AMENDMENT TO PLANNING

PROJECT
Development of 7no. new townhouses
at St Mark's Lane, Portobello
For Buckley Building

DRAWING
Elevations showing proposed minor changes from Approved design; Floor Plans, confirming internal arrangements; and Site Plan, with Roof Plan showing proposed dormer windows to street front roofs; plus for reference - original elevations as approved (extracted in PDF format from Planning Portal)

| DATE | DRAWN | SCALE |
|----------|-------------|------------------|
| 359 | PL-02 | - |

ELEVATIONS
as proposed
1:100

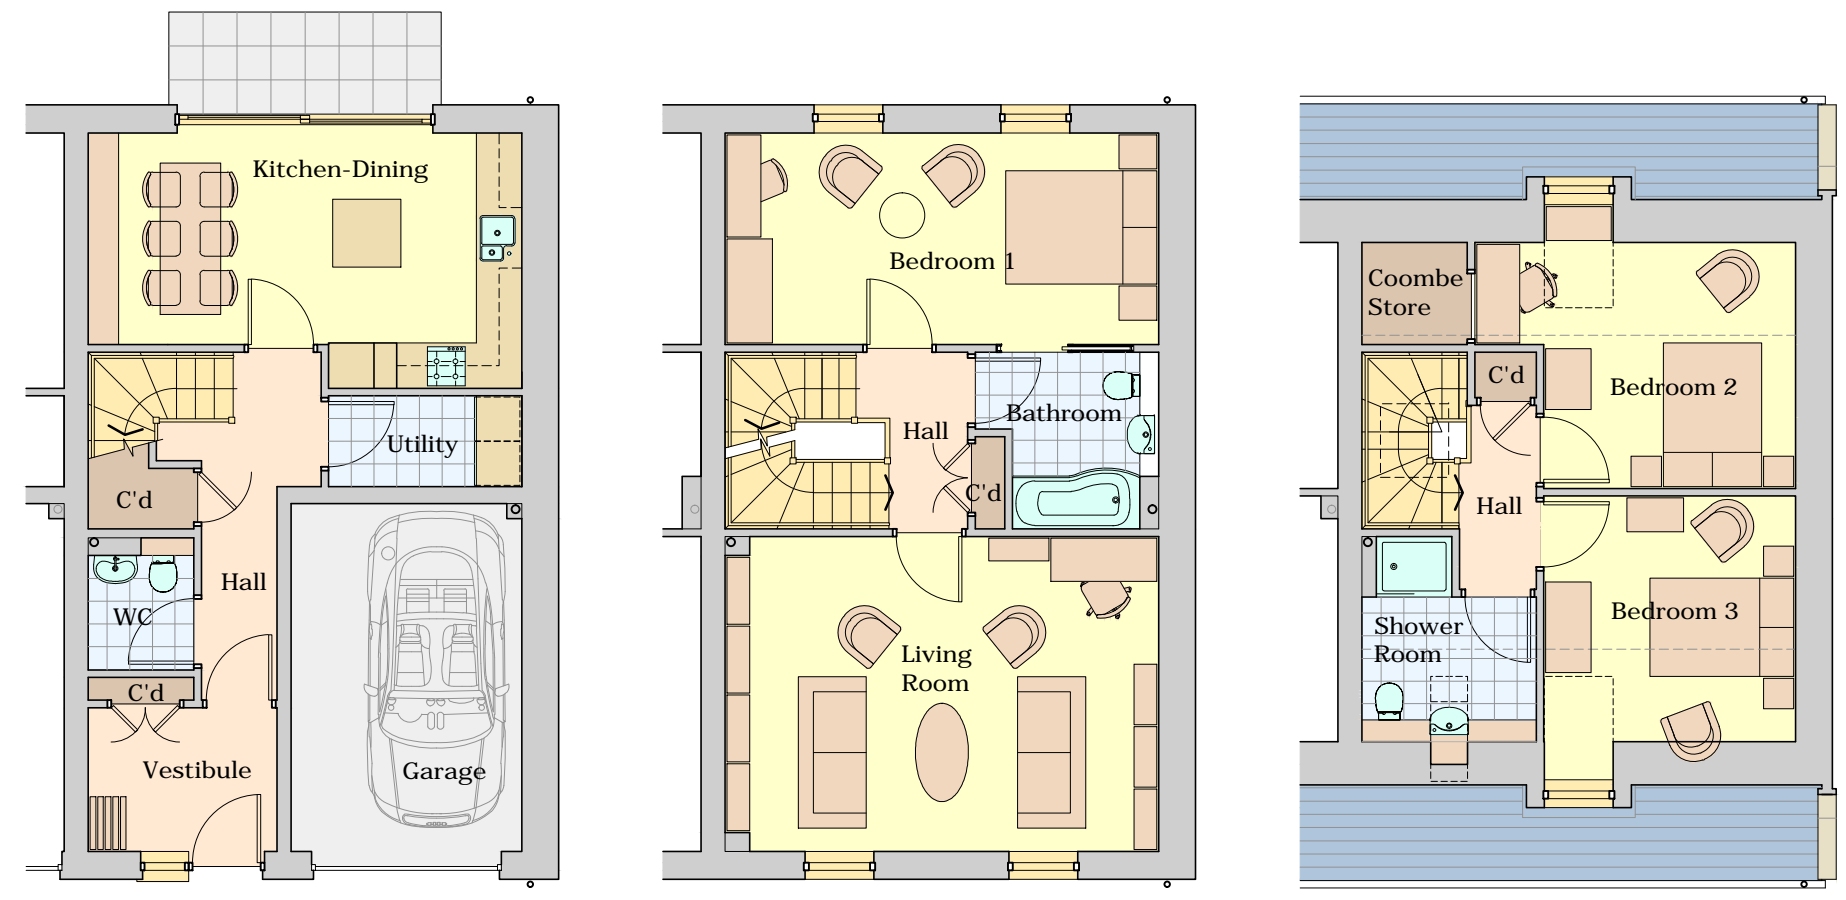
- Proposed changes to approved design are limited to:
- Formation of dormer windows (one per house) to the street front elevations of both North and South blocks, in addition to approved dormers to rear elevations. To the South facing elevation of the North block (comprising 3, narrower houses) the proposed dormer will replace 2 roof windows of differing sizes and be the only fenestration at roof level. To the North facing elevation of the South block (comprising 4, slightly wider houses) the proposed dormer will replace one large Velux roof window, and one small roof window (providing natural light and ventilation to the top floor bathroom) will be retained.

- Changes to the first floor fenestration to the rear of both blocks, comprising the reduction of the tall windows with low cills as proposed in the Approved Design to more standard height windows with a 900mm internal cill height. The proposed change is intended to provide more appropriate fenestration within the principal, garden-facing first floor bedrooms. The tall windows with low cills and "balcony" handrails (within the depth of the wall) to the front of each block, which serve Living Rooms, will be retained.

- Change to the pattern of patio doors to garden facing ground floor rear elevations to both blocks. It is proposed to install wide, timber framed sliding patio doors, rather than the folding-sliding screens of the approved design, to maximise daylight and reduce number of mullions interrupting views out to private gardens.
